Amendment to the Concrete Control Plans for silo replacement.

TZC is replacing the original concrete batch plants' three 65 Ton silos with one 52 Ton silo and one 82 Ton split silo per plant. This will be done on batch plant 1 & 2, they will have identical equipment.

Revised APPENDIX B
Barge Drawings and Airflow Diagrams

TITLE OF PROJECT: THE NEW NY BRIDGE CONTRACT NUMBER: D214134

TITLE OF DRAWING:
Batch Plant Profile View

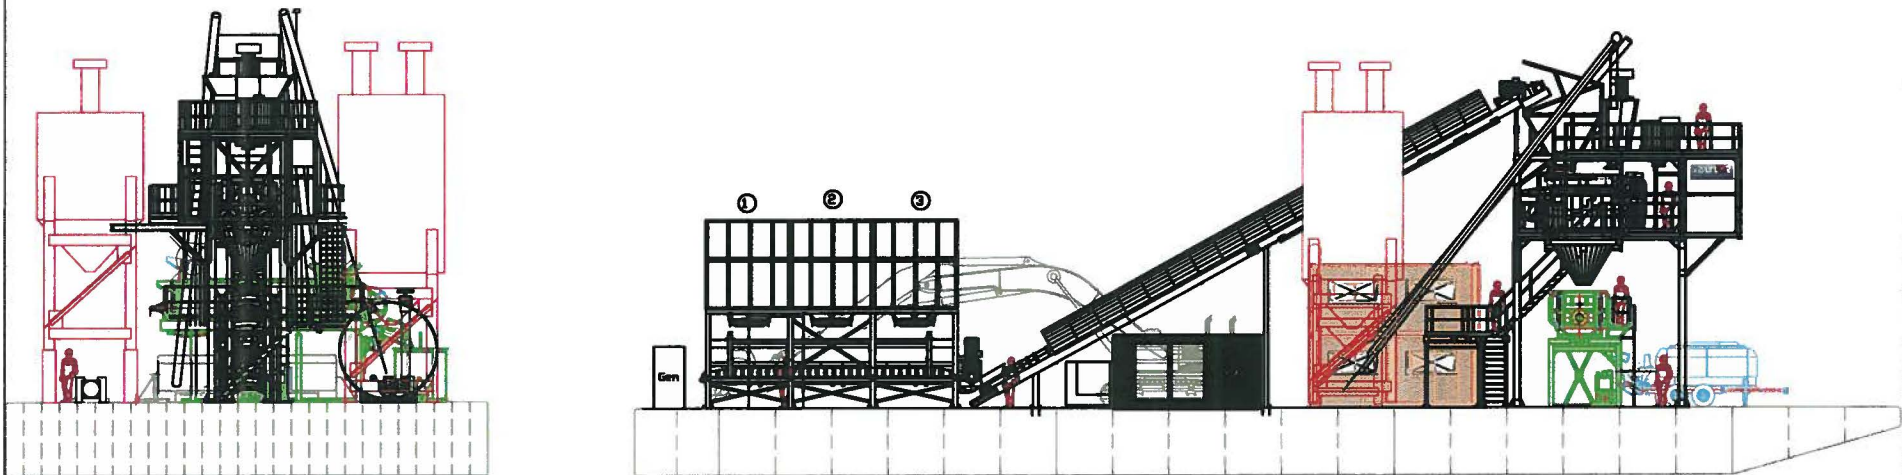
The silos will be equipped with 99.9% efficient WAM SILOTOP R03 Dust collectors. Each silo will have High and Low level indicators with lights and an emergency jamgate to stop the flow of product out of the silo in an emergency.

TITLE OF DRAWING:	Air Flow Diagram
-------------------	------------------

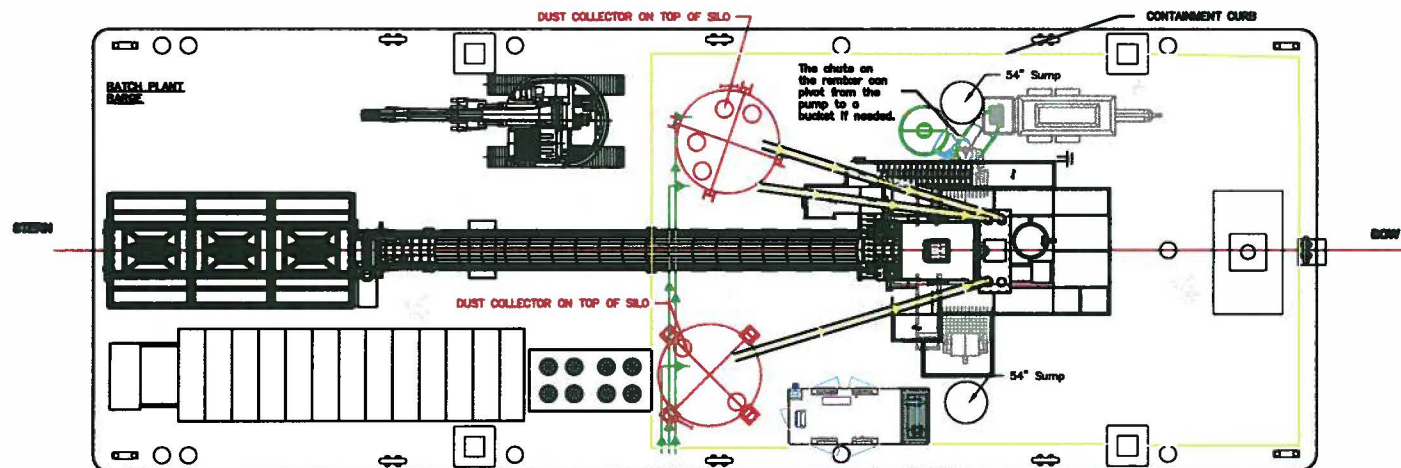
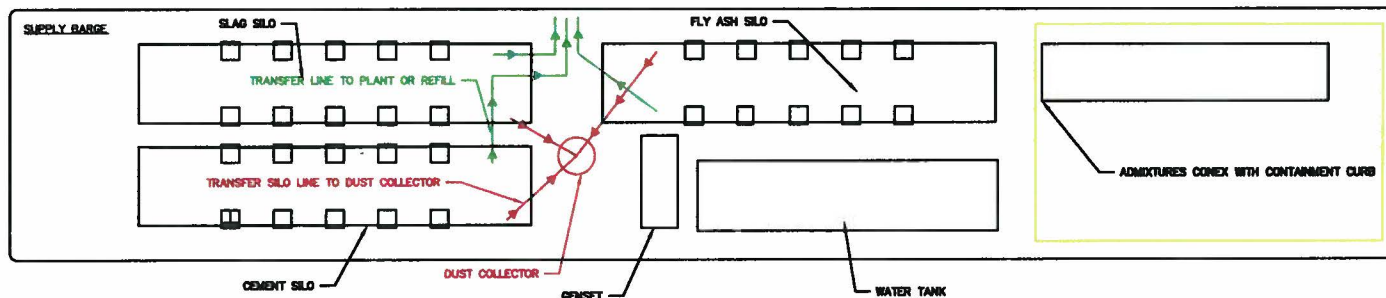
The Green transfer line is the flow of material from the supply barge silo's to the plant plant barge silo's when unloading. Once material is in the plant barge silo's it will be conveyed to the plant through augers shown in yellow.

The Green transfer line on the supply barge double as the fill lines when taken to land.

The Red line are the vent lines used to vent air pressure when loading or unloading to capture the dust in the vented air.

Items labeled dust collector in RED are points where vented pressure will capture dust from the either end of this closed system.

TITLE OF DRAWING:
Barge Layout in Production

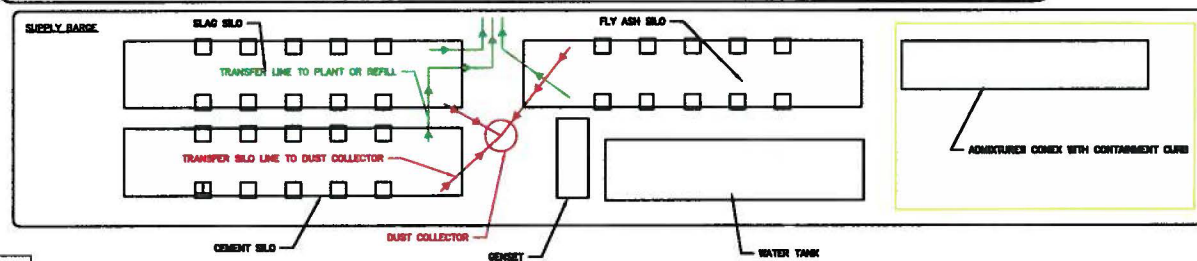
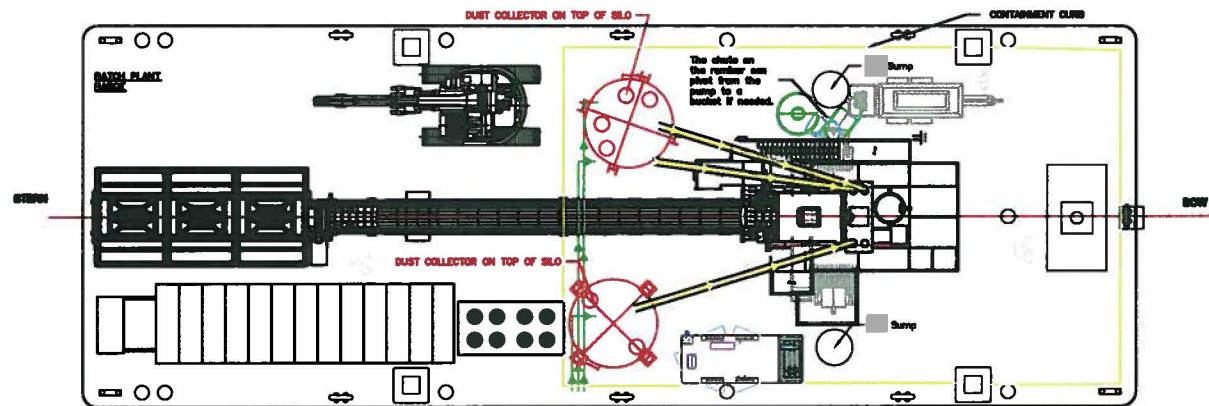
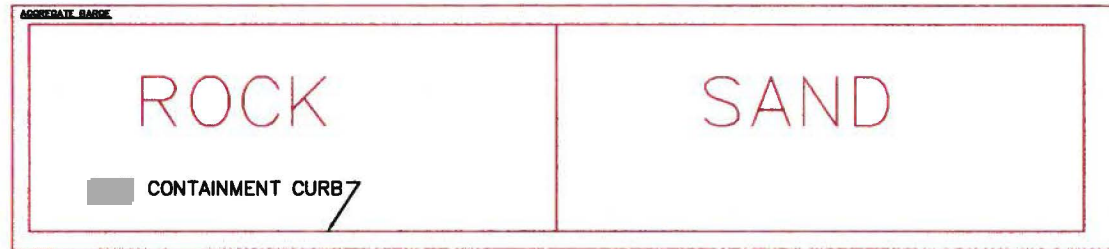
Barge Layout in Production.
